ADDENDUM 1

REF: Bid 2022-09 Portable Classroom Improvements at Five Schools

The following changes are made a part of the Drawings and Specifications for the project named above. Receipt of this Addendum is to be acknowledged in the space provided on the Bid Form. Failure to do so may subject the Bid to be considered as non-responsive.

JOB NUMBER: 219	909
ISSUE DATE: 31 AUGUST, 20	021
SCALE: AS INDICA	TED
SHEET TITLE:	
STRUCTURAL FOUNDATION PLAN , DETAILS, AND NOTES	
SHEET NUMBER:	
S100

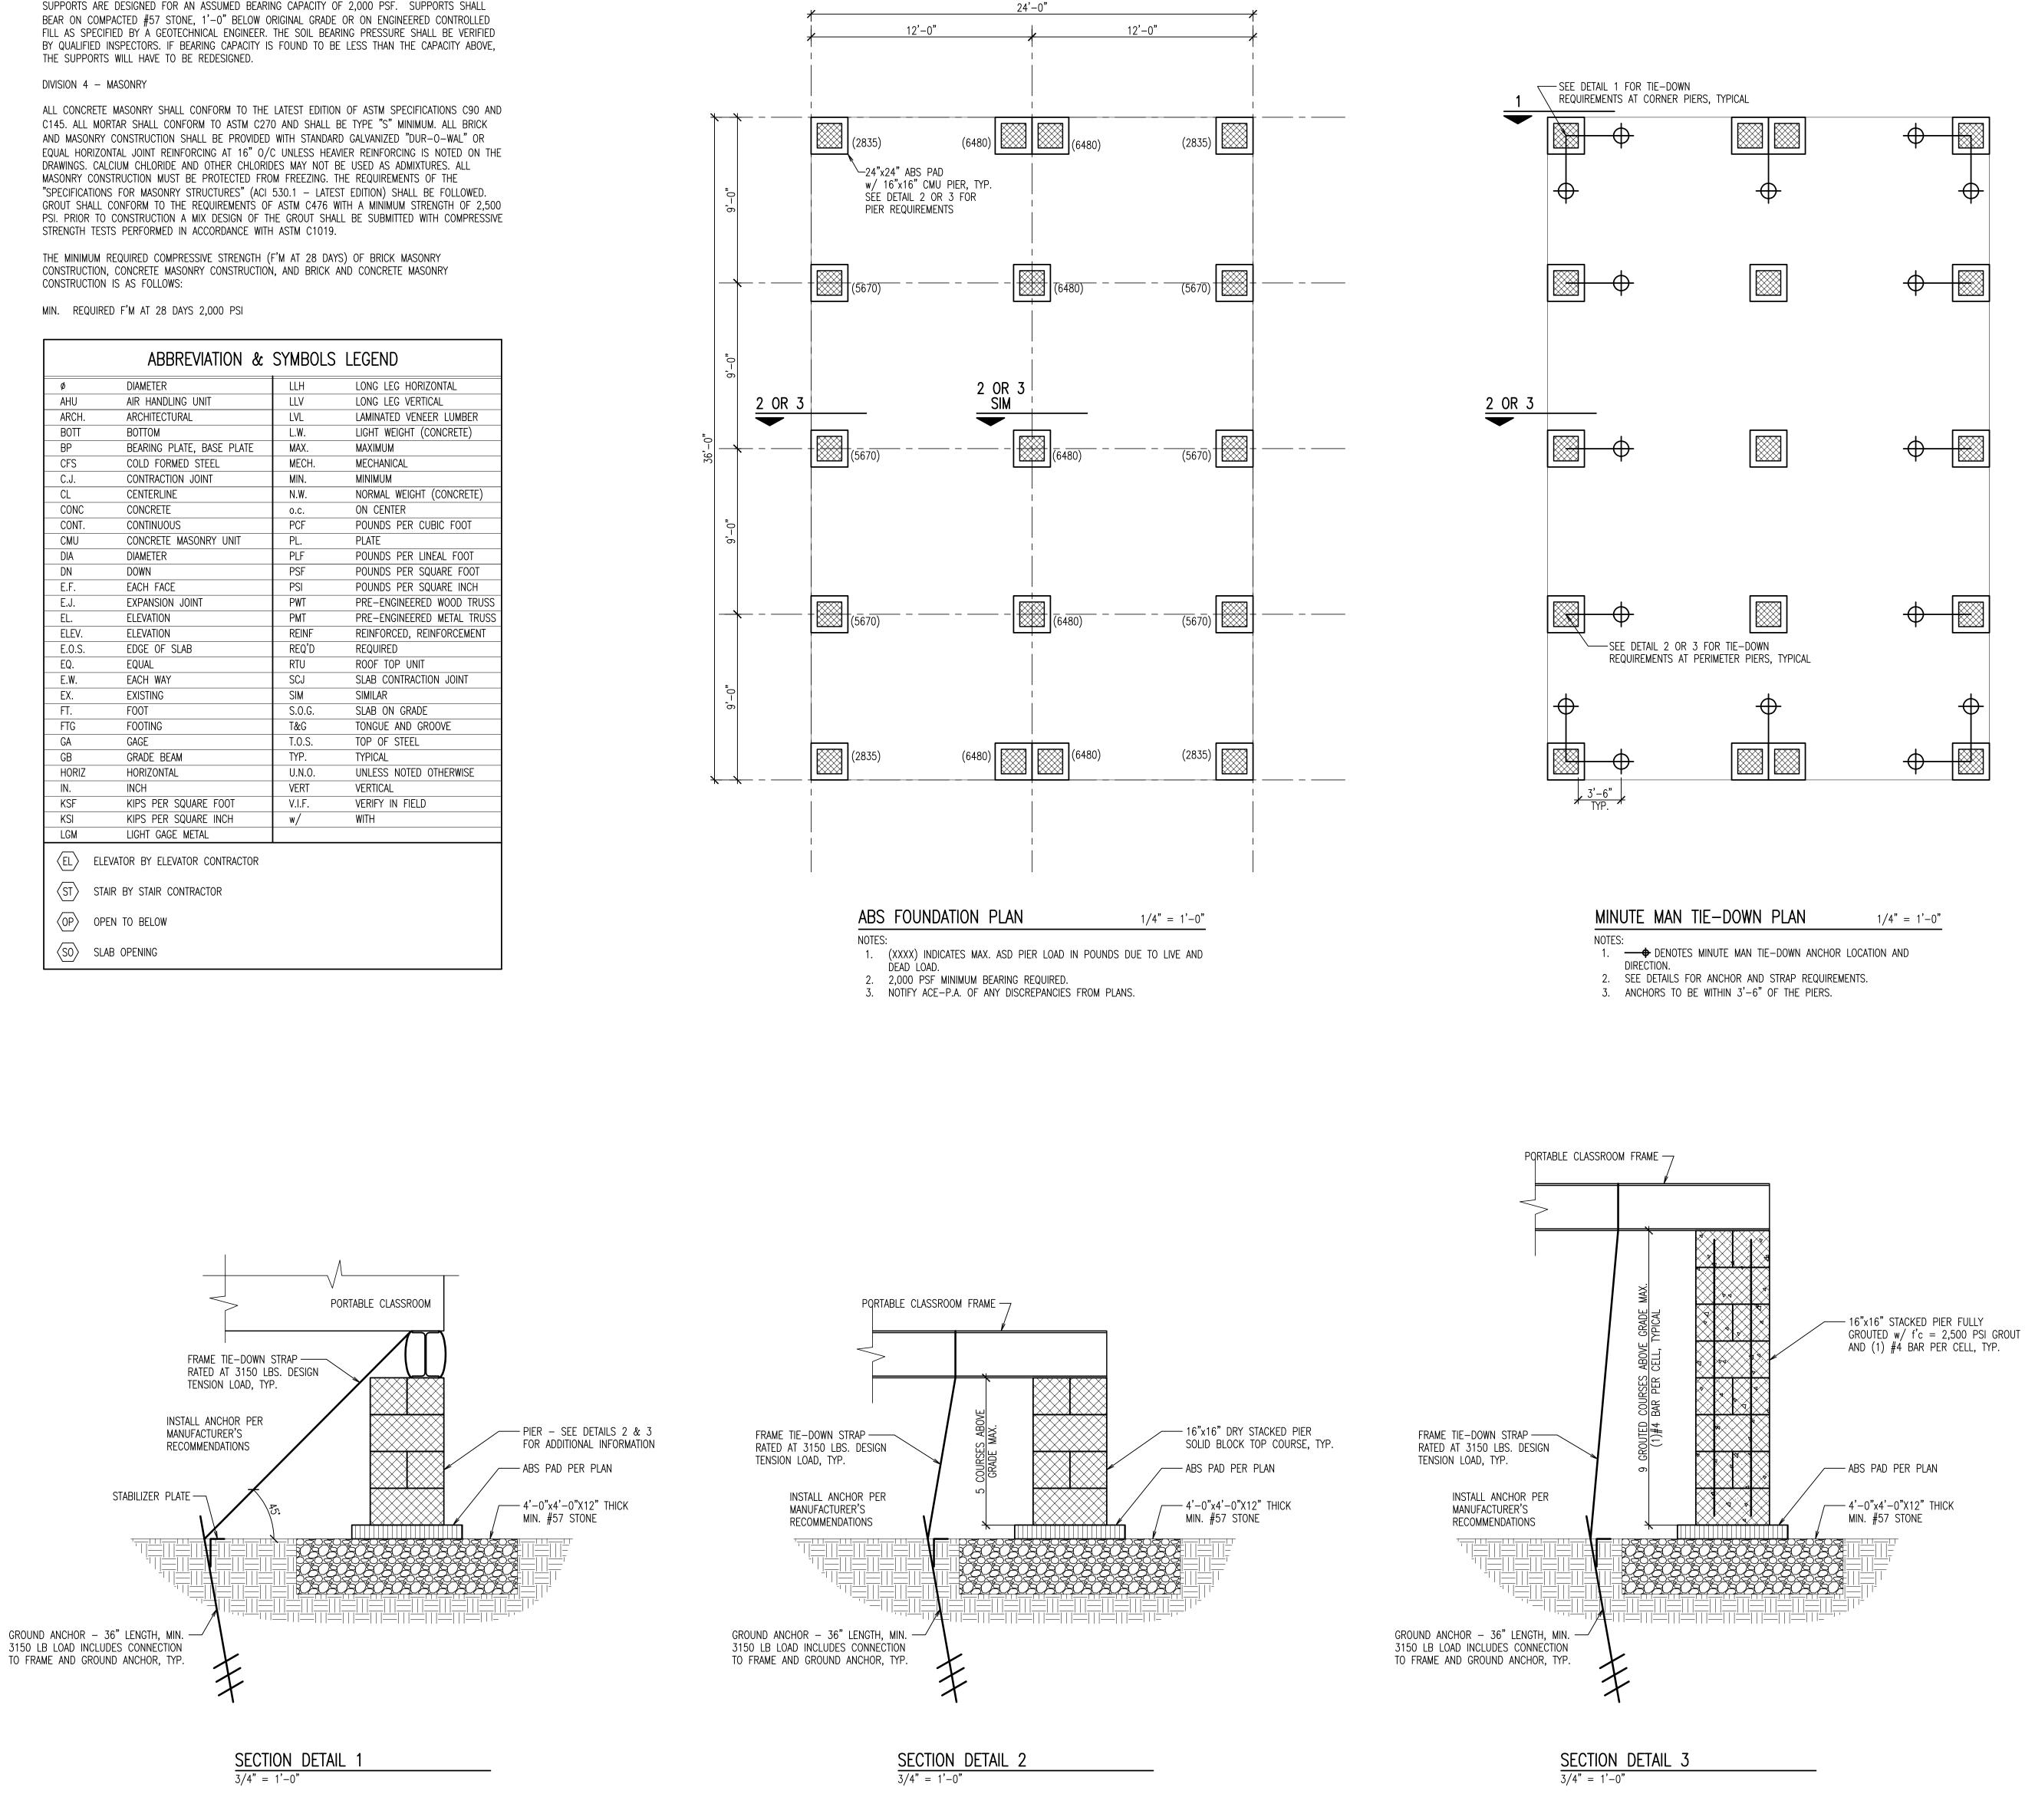
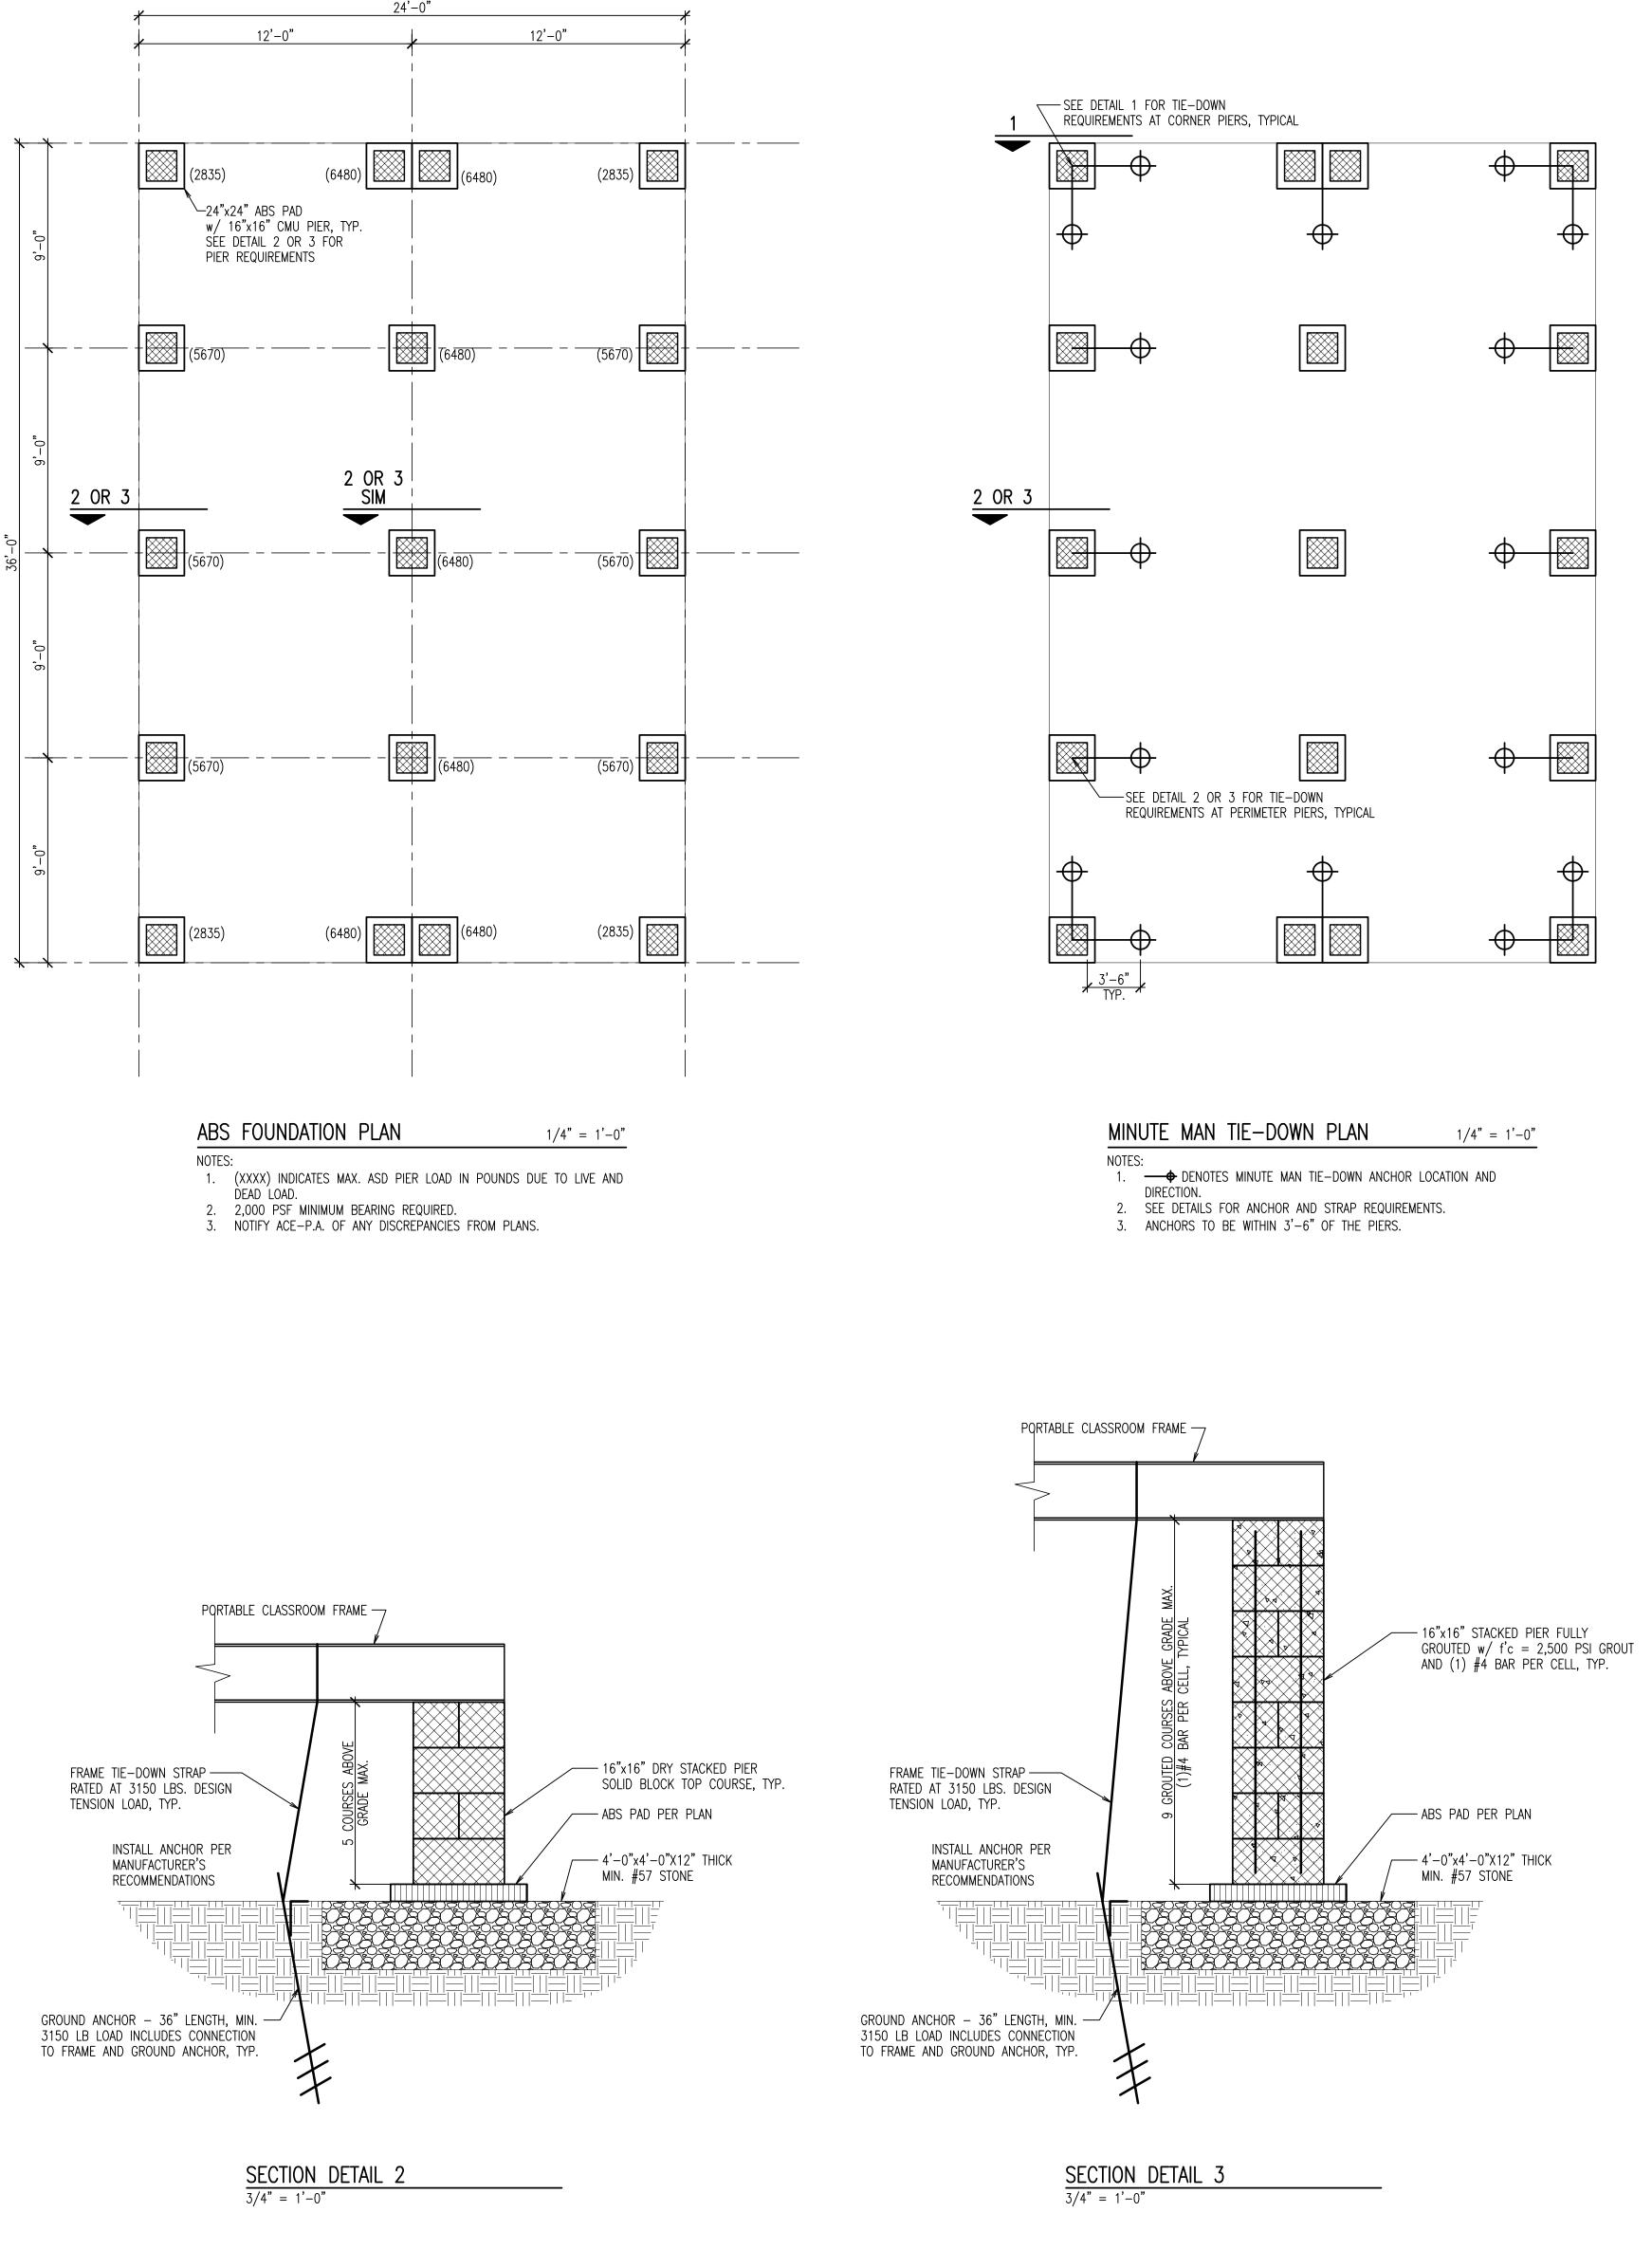
- 1.4 Q: Why are there footer and block pier details on Drawing A100?
 A: The details in question are to be used for the ramp foundations, where applicable. The details on S100 (attached to this addendum) apply to the relocated portable buildings at NHHS.

- 1.24 **ADD** Drawing S100, attached to this addendum. These structural details apply to the relocated portable classrooms at NHHS.
- 1.25 **DELETE** Sheet A100 and **REPLACE** with revised Sheet A100, attached to this addendum.
- 1.25 **DELETE** Fox & Associates' NHHS Drawings (Sheets 1-2 of 23 of the PDF) and **REPLACE** with the revised drawings attached to this addendum. The existing portables at NHHS shall be moved to a new location at NHHS within this project's scope of work.
- 1.26 **DELETE** E301 and **REPLACE** with revised E301 attached to this addendum.
